Product hierarchy no. *			Part no.	SBU	Type / Description	Customer part no.
SBU	PG	PGU	Type			
01	001	007	0000000032	See list below	Circuit Protection	SPT 6.3x32 10-32A

## 2 Type of change

SPT 6.3x32					
creation date	created by	release date	released by	notification no.	revision
11.2.2015	SHÖ	17.2.2015	SHÖ	xxx	1 von 1

List of part numbers affected						
0001.2534	0001.2535	0001.2536	0001.2537	0001.2538	0001.2539

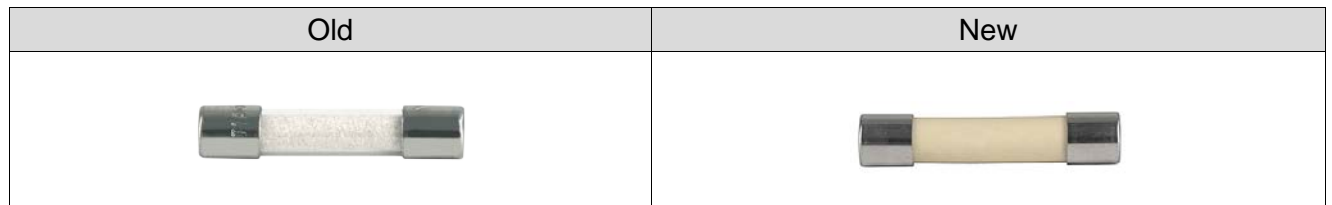
The tube material changed to ceramic.

Fuse element is now soldered internally to ferrules. Used to be soldered externally.
